TECHNICAL BULLETIN

MODEL/DERIVATIVE:
Defender

Bulletin N°: 0066
CDS. ref: L8615bu
Issue: 1
Date: 25.04.01

PROBLEM:
SHRINKAGE / POOR FIT OF CANVAS HOOD

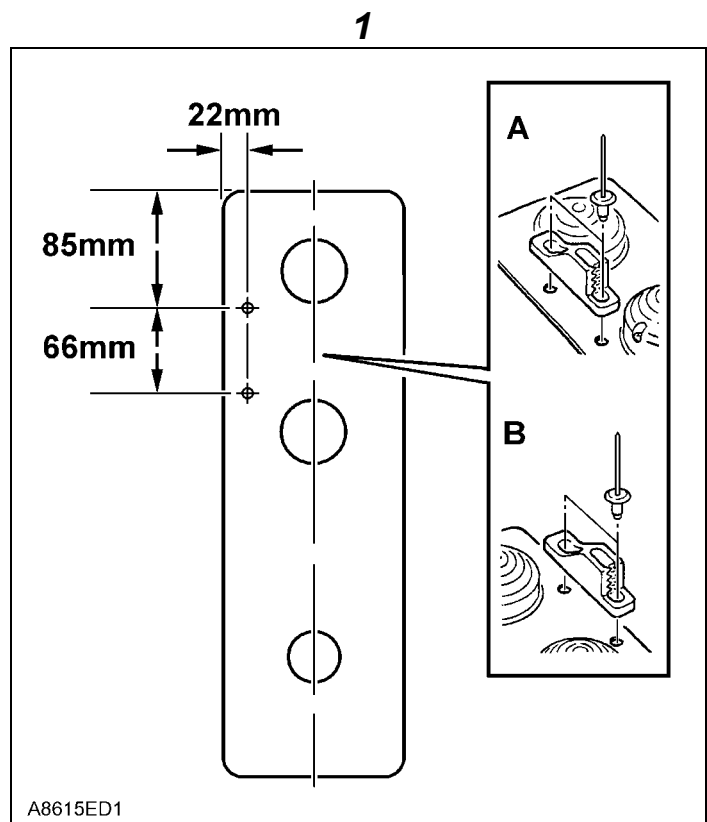
110 High Capacity Pick Up (HCPU) and 130 Crewcab

1. Remove the existing hood.
2. Remove both rear lamp assemblies.
3. Referring to illustration 1, drill two holes in each rear lamp mounting plate as described below;
 - RH assembly, (illustrated). From the top face of the mounting plate, measure 85mm vertically down the LH edge of the plate and mark.
 - From this point, measure down a further 66mm and mark.

- At each of the marked positions, mark a point 22mm from the LH edge of the plate.
- Drill a 4.9mm hole at each position.
- Repeat for LH assembly, positioning holes on the RH side of the plate to produce a mirror image of the RH assembly.

Take care to produce one right and one left handed modification.

4. Attach one cleat DJL000010 to each mounting plate with orientation as shown in inset 'A', (RH) and inset 'B' (LH), using two rivets RRC4583 for each cleat.
5. Refit rear lamp assemblies.
6. Fit replacement hood. Refer to *PARTS INFORMATION* for derivative / part number detail.

90 Truckcab and 110 Truckcab

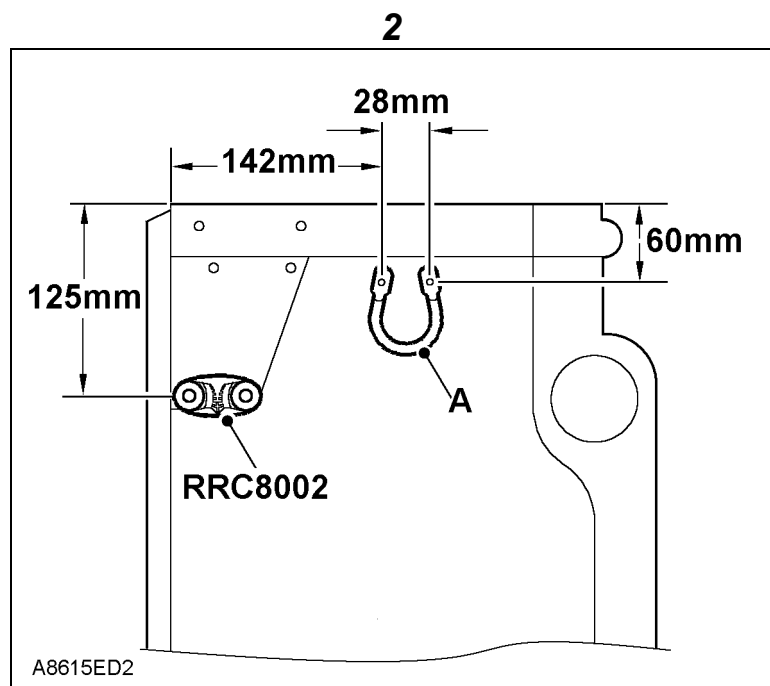
1. Remove existing hood.
2. Referring to illustration 2, reposition existing cleats 'A' as described below, (illustration shows new location, RH side of vehicle);

- Drill out rivets and remove both cleats 'A'.
- Using dimensions from illustration 2, mark out the new locations for the cleats.
- Drill two 5.2mm holes for each cleat at the new locations.
- Attach the cleats at their new location using rivets RU612373L.
- Fill holes at original cleat locations using rivets RU612373L.

3. Still referring to illustration 2, identify the locations for two new cam cleats RRC8002 and fit as described below.

- Locate two rivets at the lower edge of the reinforcement plate on each side of vehicle, approximately 125mm below top edge of body.
- Drill out these rivets and increase the hole size to 6mm.
- Attach new cam cleats RRC8002 using screws SE105301L, washers WA105001L and nyloc nuts NY105041L.

90 Soft Top and 110 Soft Top

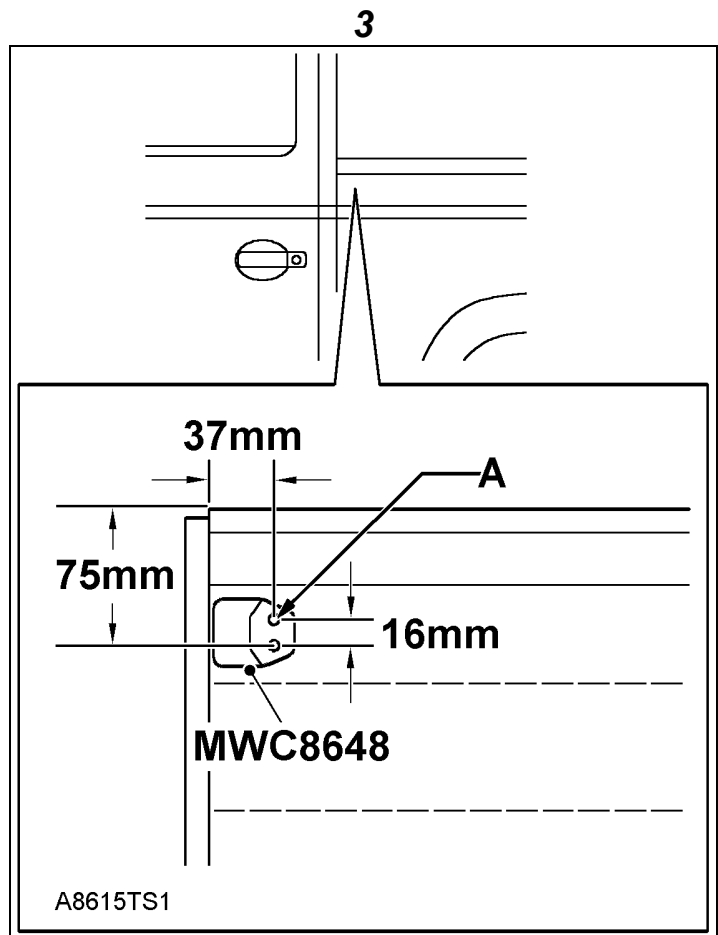
1. Carry out operations 1 to 3 as for 90 and 110 Truckcab above.

2. Referring to illustration 3, remove existing cleats at forward sides of rear body as described below, (illustration shows new location, LH side of vehicle);
3. Drill out rivets 'A' and remove both existing cleats.
 - Using dimensions from illustration 3, mark out the new locations for the cleats, (the existing holes cannot be used as their centres are incorrect).
 - Drill two 5.2mm holes for each cleat at the new locations.
 - Fill holes at original cleat location using rivets 78248.
 - Attach new cleats MWC8648 at the new locations using rivets 78248.
4. Fit replacement hood. Refer to *PARTS INFORMATION* for derivative / part number detail.
